Expert Opinion on Drainage Issues

Amendment GC28 to the Whittlesea and Mitchell Planning Schemes

Report Author:	Warwick Bishop
Report Prepared for:	DFC (Woodstock) Pty Ltd
Instructed by:	HWL Ebsworth Lawyers
Report Date:	9 May 2016

Figure 8-3 Location of east-west waterway and topographic constraints

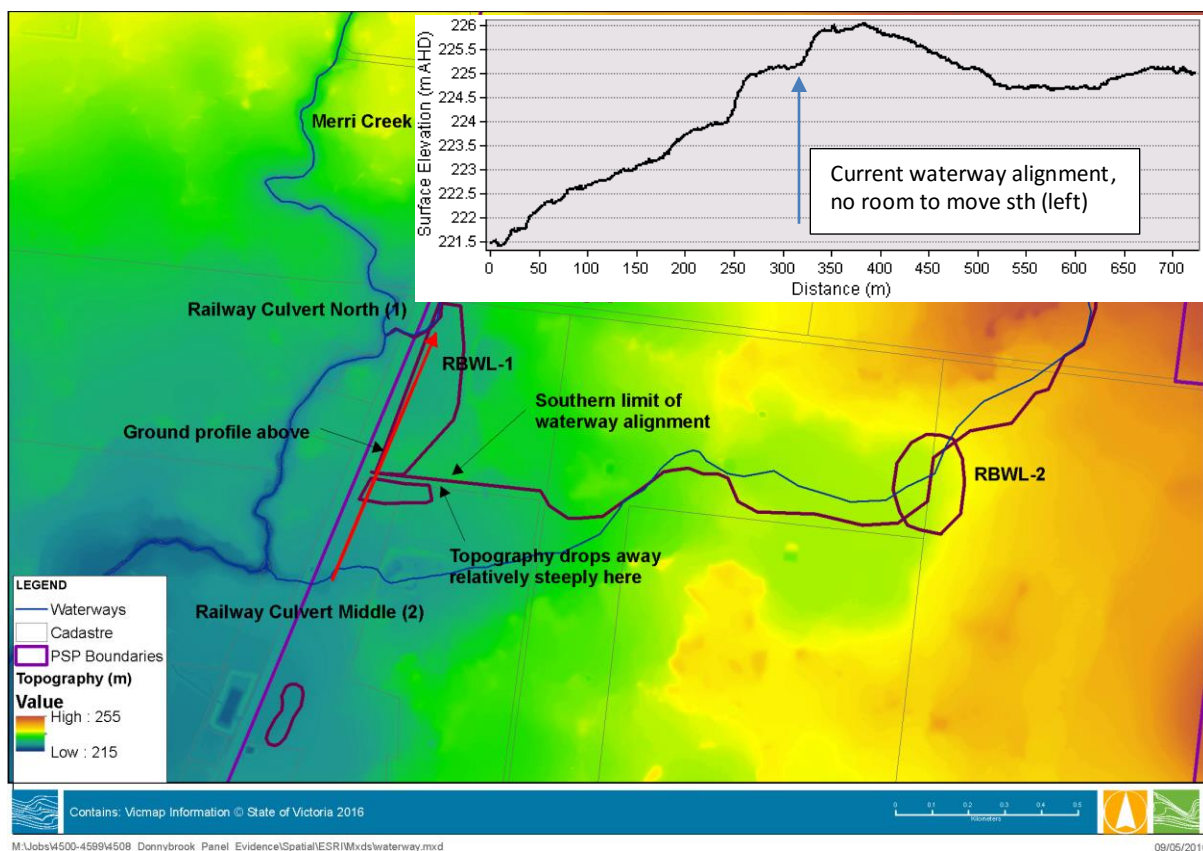
Due to the relatively flat terrain and poorly defined valley to the west of RBWL-2, the exact alignment of the main east-west waterway could be adjusted in some areas, however I do not consider that the alignment could move any further south than is presently the case. Figure 8-3 below illustrates that the present alignment is as far south as would be feasible in order to be able to discharge to the northern railway culvert. Any distance to the south (left on the section matching the red arrow), would result in a drop away to lower ground that would not be practical. As the intention of the DSS is to discharge both the northern and southern Merri Creek tributary catchments to the northern railway culvert, moving the channel south would hinder this task.

Figure 9-1 RBWL-2 existing topography

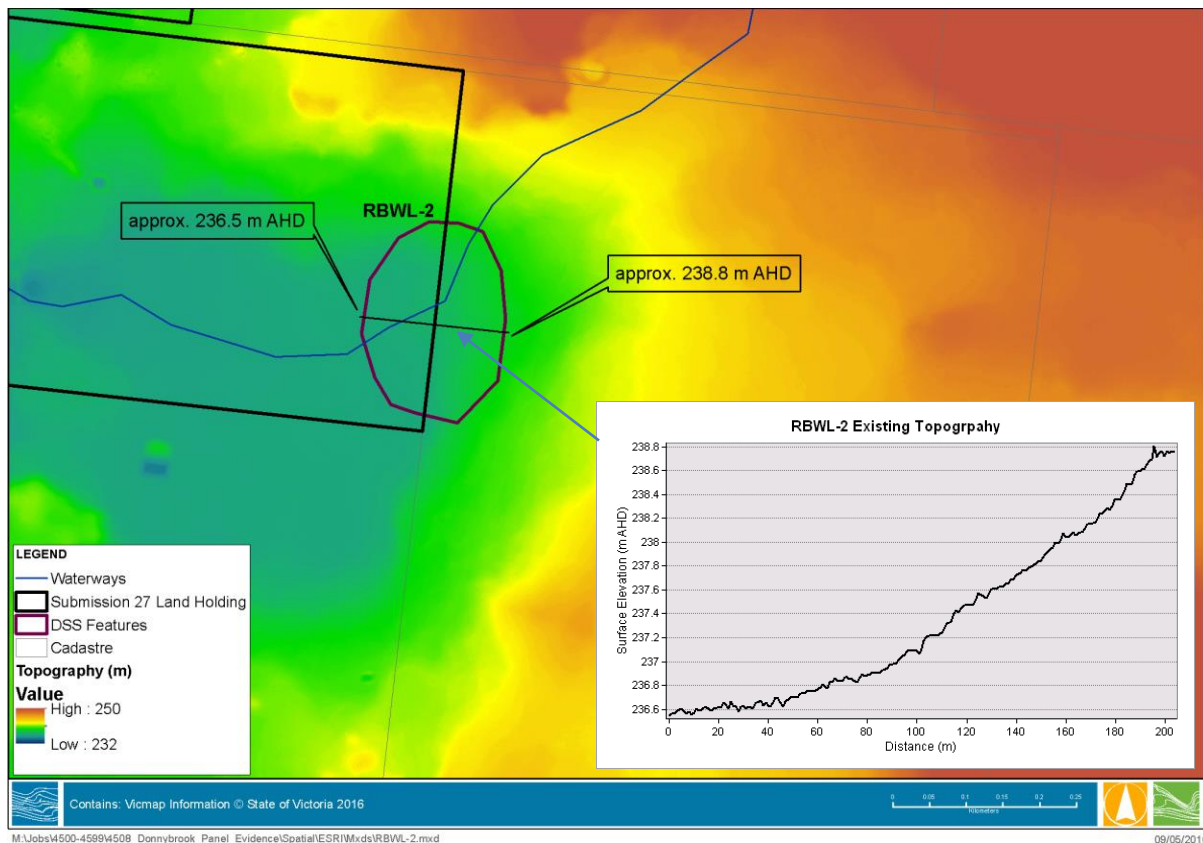
- 3. *Retarding Basin Wetland-2 (RBWL-2) should not be located as shown on plan 14:*** It is suggested that this RBWL should be relocated to the east onto a neighbouring property. I do not believe this is a feasible option. As currently presented in the DSS, RBWL-2 already presents a design challenge as it has been moved east from a previous version of the plan and now straddles the property boundary. It also extends into a significant rise to the east as can be seen in Figure 9-1 below. This shows there is more than 2 m rise in elevation from west to east across the proposed RB location. This will require either significant excavation on the eastern side or construction of a substantial embankment on the west side. This may lead to significant design difficulties and an increase in costs for the DSS. This is not consistent with DSS Principle 4, “Schemes should propose infrastructure to service development that is optimal in terms of cost and performance”. Moving the RB further east will only exacerbate these issues and is considered impractical.

Figure 9-2 Existing topography profile along proposed waterway alignment

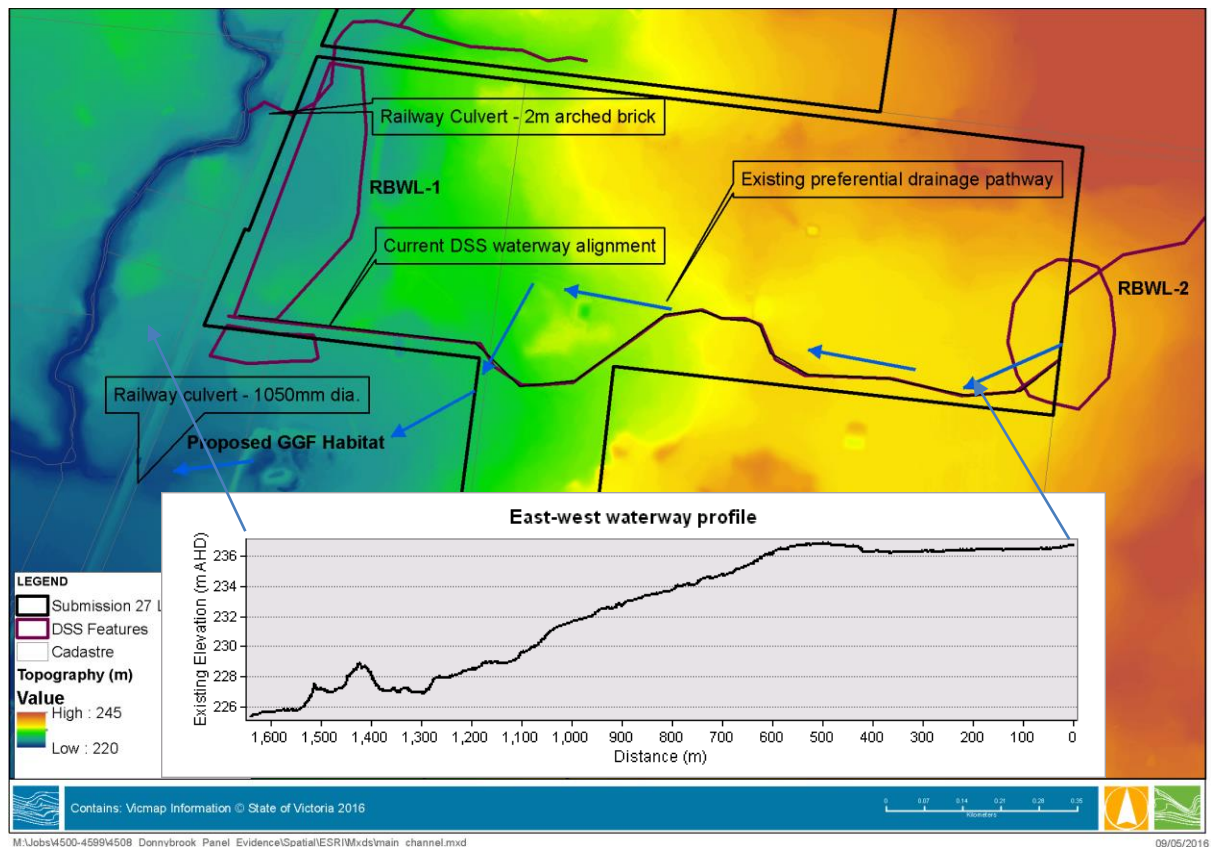
5. **The main channel from east to west does not follow known contours and no natural watercourse exists:** It is evident from the existing conditions topography as well as background documents (e.g., Condina and Associates, 2015) that there is no clearly defined existing waterway in the vicinity of the proposed east-west constructed waterway in the Donnybrook PSP area. Analysis of the topography indicates there is a preferential overland flow path that passes east to west through the Submission 27 land holding and then veers south towards the proposed GGF conservation area before discharging under the railway line via a 1050 mm culvert. During periods of high flow it is expected that some runoff would break away to the north-west and flow towards the northern culvert (2m brick arch).
